# **WORKSHOP ON THE PAKS II SITE CHARACTERISTICS**

*Assessment of the Hungarian-Austrian  
professional workshop on the Paks II site  
characteristics in Budapest, Feb 15, 2022*

REPORT  
REP-0828

Figure 1.  
Phenomena depicted by  
S-wave reflection seismic  
lines from the Paks II site  
that cannot be inter-  
preted as surface noise,  
and thus indicate fault  
offsets.

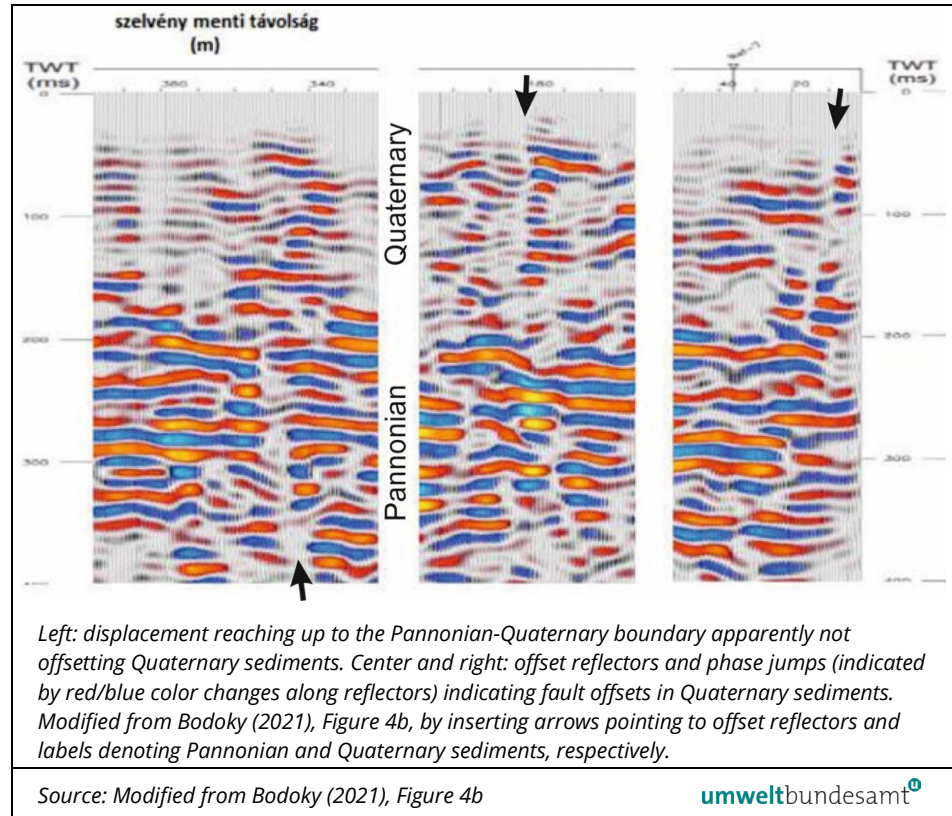
In a later interpretation of the same S-wave reflection profiles, T. Bodoky (2021) introduced a method for discriminating between seismic signals derived from the anthropogenic backfill and reflection patterns indicative of faults. This approach, in which “phase jumps” (sudden phase changes along a traceable seismic horizons) are reliable indicators of fault offsets, led to the identification of numerous faults cutting the top of the Pannonian strata and continuing upwards into the overlying Quaternary sediments (Figure 1). The data allow tracing faults up to a minimum depth of about 50 ms shear wave TWT (circa 7 meters according to the s-wave velocity estimated by Bodoky, 2021). Bodoky (2021, p. 212) concludes that the shear-wave reflection data makes it “*quite certain*” that Quaternary sediments are faulted. Bodoky (2021) further provided a map of the Paks II site showing the locations of faulted or fractured zones (“*törésez zavart zona*”). A tentative interpretation of the 15 S-wave reflection lines included in Ács et al., 2016, Attachments 4–7 by the EAA experts revealed similar results (Figure 2). The EAA experts only considered faults that were interpreted to affect overlying Quaternary sediments. The results of both interpretations highlight numerous fault/fracture zones (Bodoky, 2021) and fault sticks (EAA experts) within the Paks II site area (Figure 2). Fault sticks tend to line up along SW-NE- to SSW-NNE-striking structures, i.e., parallel to the strike of the Dunaszentgyörgy-Harta fault zone.

The S-wave reflection data and the interpretation by Bodoky (2021) are regarded as vitally important for assessing the seismotectonic conditions at the site: The data cover the actual construction site of the planned reactor buildings and other structures important to nuclear safety.

Figure 3.  
Surface-breaking fault excavated in the trench Pa-21-II serving as “an example of characteristic neotectonic deformation features” in the map of Young Geological Deformations in Hungary by Wórum et al. (2020).

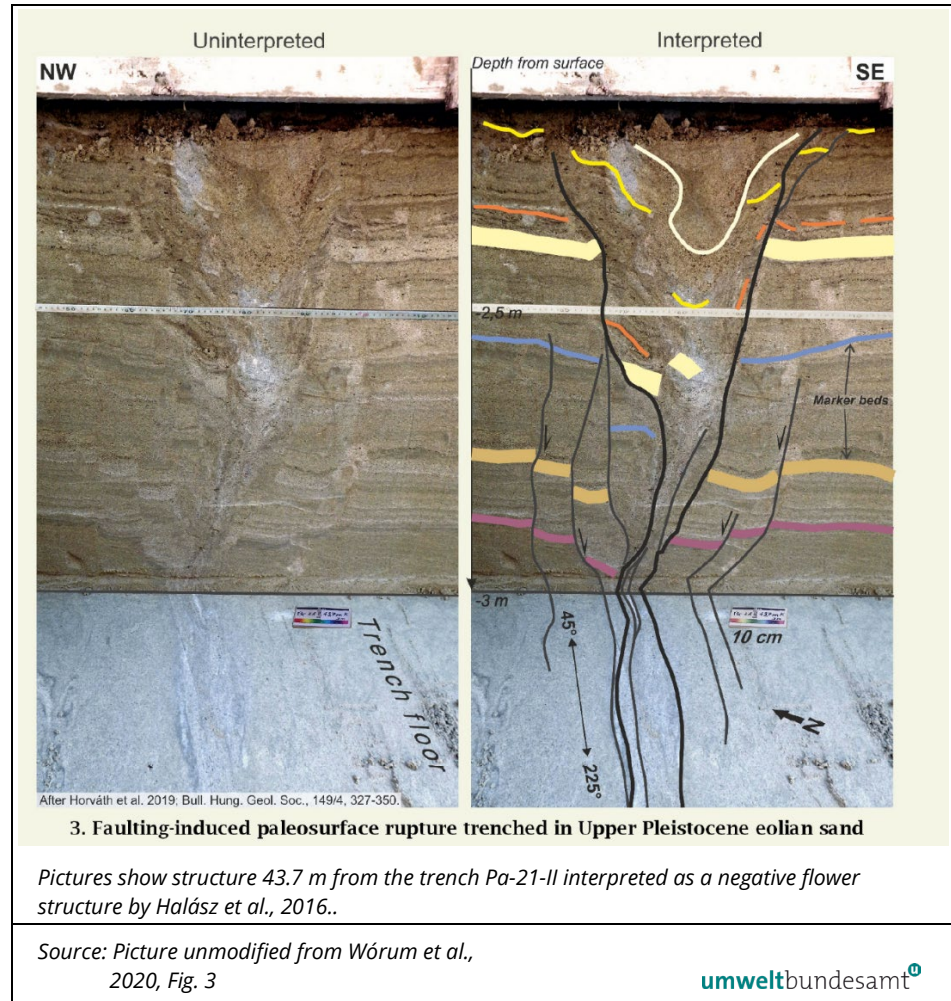
The structures observed in Pa-21-II are strikingly similar to published trench observations across strike-slip faults, such as the faults related to the 1999 Izmit (Turkey) Mw=7.4 and the 2010 Darfield (New Zealand) Mw=7.1 earthquakes (Dikbas et al., 2018; Hornblow et al., 2014): They all show very narrow sub-vertical deformation bands with no or small vertical offset distributed over the length of the respective trench walls. The faults terminate upwards in sediment-filled fissures. The similarities to the published trench studies support the interpretation of the observations in trench Pa-21-II as the result of at least two surface-breaking earthquakes along a strike-slip fault (Figure 4). In addition, both studies conclude that vertical offset observed within the trenches underrepresent the total surface offset related to the respective earthquake. Hornblow et al. (2014) even state that only approximately 30% of surface displacement that occur in strike-slip earthquakes are manifested along surface-breaking faults. Therefore, the slip estimation of only few centimeters along the Dunaszentgyörgy-Harta fault zone based on the trenching observation must be considered as an absolute minimum offset.

Consequently, the IAEA criterion for the identification of a capable fault is clearly met:

Figure 5. Comparison of maps showing fault locations within a 50 km radius of the Paks II site on the background of a depth structure map.

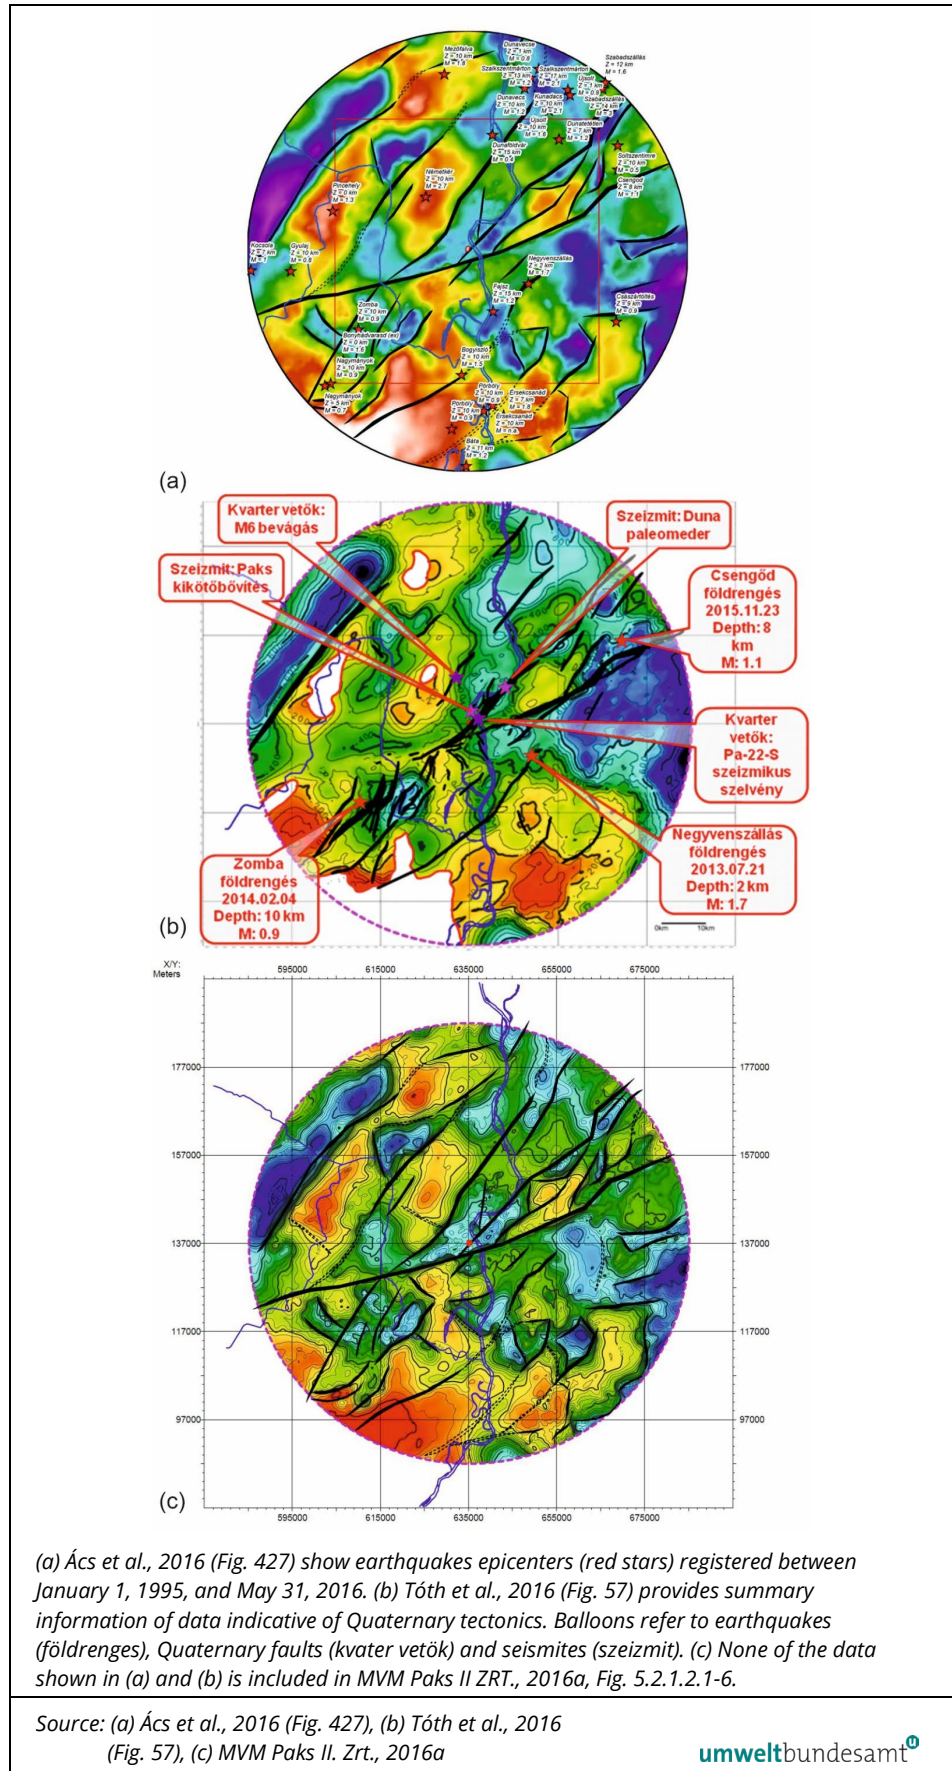
In light of this, it is remarkable that neither the HAEA nor the Mining Authority identified or questioned the discrepancies between the contents and conclusions of the Geological Site Report and the Site Safety Report highlighted by Decker & Hintersberger (2021). The most significant and obvious inconsistencies between the two reports, highlighted by the authors cited, concern the following issues:

al., 2016, Fig. 57; Ács et al., 2016, Fig. 427; and MVM Paks II ZRT., 2016a, Fig. 5.2.1.2.1–6 (Figure 5).

The EAA experts still recommend requesting additional information on how the HAEA and the Mining Authority dealt with the documented discrepancies between the cited reports.

Figure 6.  
Comparison of the  
location of the  
Dunaszentgyörgy-Harta  
fault zone (DHFZ) and  
accompanying branch  
faults (red polygons)  
shown by Paks II Zrt.,  
2016a

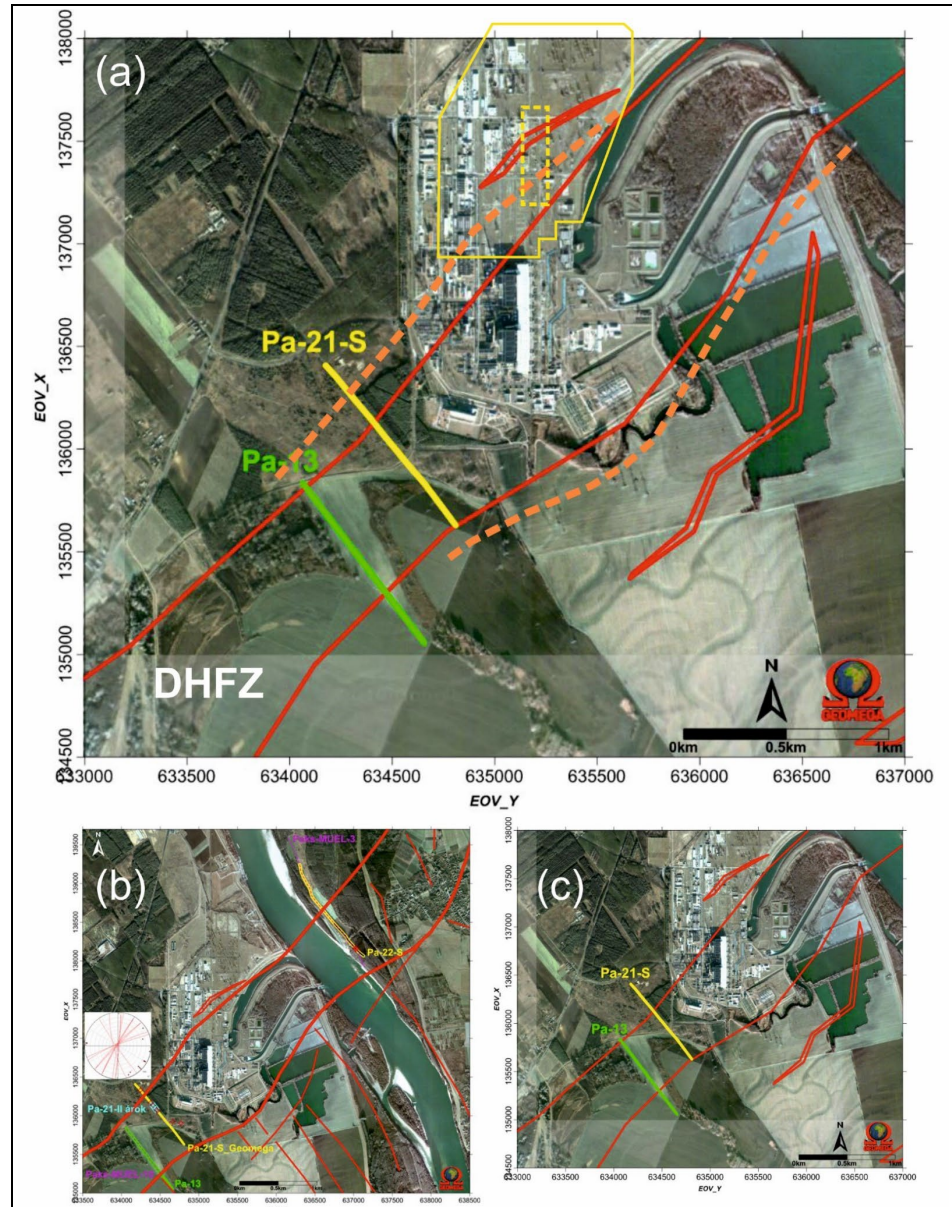
- the location and extent of the DHFZ below the Paks II site as shown by Ács et al., 2016, Fig. 418; and MVM Paks II ZRT., 2016a, Fig. 5.2.1.2.6–1 (Figure 6).
- the disregard of paleoseismological evidence for the occurrence of ground-rupturing earthquakes in the last 30,000 years included in different parts of the report by Ács et al. (2016; for a compilation of the data and references see Decker & Hintersberger, 2021, Tab. 1)

Figure 7.  
Location of the trench  
Pa-21-II above the  
Dunaszentgyörgy-Harta  
fault zone (DHFZ) shown  
in Halász et al. (2016),  
Figure 45.

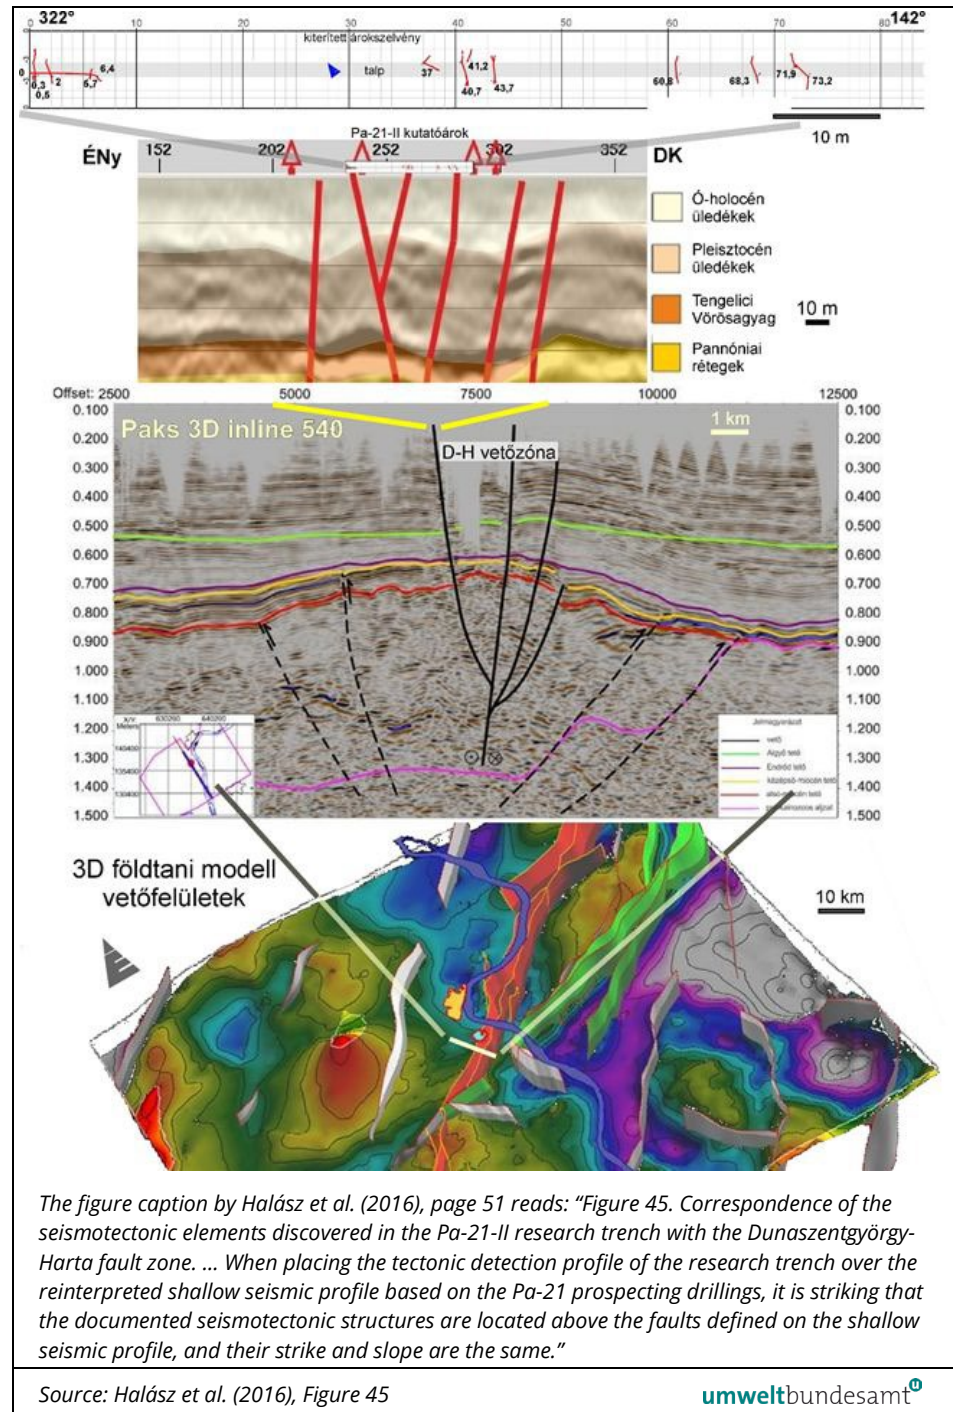
**[4]** Faults in the trench Pa21-II are not direct continuations of the fault branches at depth.

The statement by Konrad et al. (2021) contradicts the earlier interpretation of the same authors illustrated and described in Halász et al. (2016), page 51, Figure 45. The cited figure explicitly links the faults in trench Pa-21-II with the deep structure of the Dunaszentgyörgy-Harta fault zone (Figure 7):

**Final conclusion** The issue requires further information and discussion.

Figure 8. Thickness map of backfill at the Paks II site

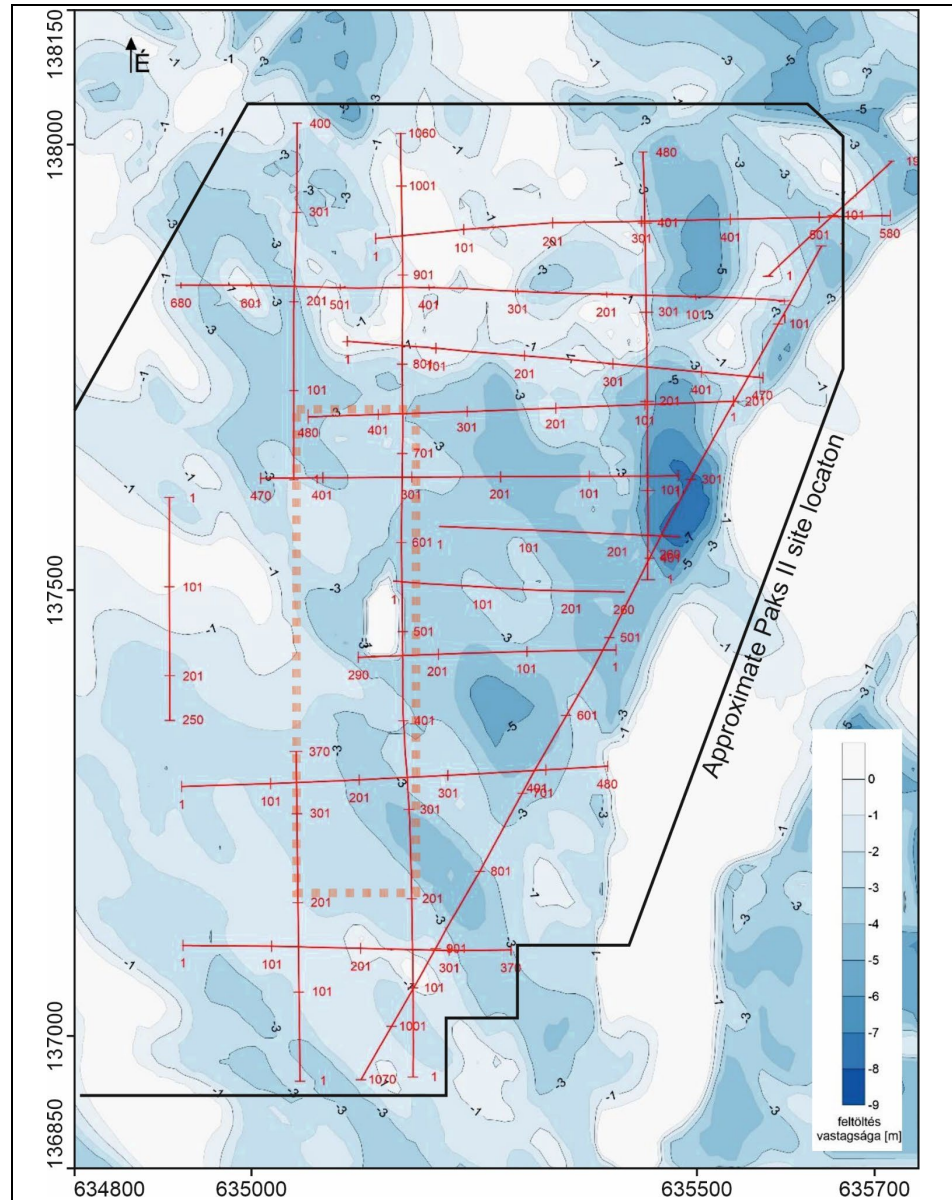
The EEA experts caution that a meaningful paleoseismological documentation cannot be achieved by monitoring excavation work alone. Robust data can only be obtained from excavations with thoroughly cleaned and logged trench-wall surfaces, a requirement which cannot be expected from routine earthwork. The planning of earthwork needs to account for the time required to establish such outcrop conditions and documentation of the profiles with a level of detail comparable to those for the trench Pa-21-II (Hálasz et al., 2016). A convincing data set to disprove the existence of capable faults will require trenches trending approximately perpendicular to the strike of the Dunaszentgyörgy-Harta fault zone and covering, as a minimum, the whole length of the future reactor buildings and other SSCs relevant to safety.

Tóth et al. (2016, Fig. 77) provide a thickness map of the anthropogenic fill at the Paks II site, which shows that backfill covering natural soil is in some places much less than 5 m thick (Figure 8). It thus seems that the first phase of excavation will also affect the uppermost and youngest layers of sediments deposited as a result of natural processes. Documenting whether the latter layers are undeformed or penetrated by faults is of utmost importance for a rigorous paleoseismological assessment. Proper documentation should therefore be required from the very early stages of excavation.
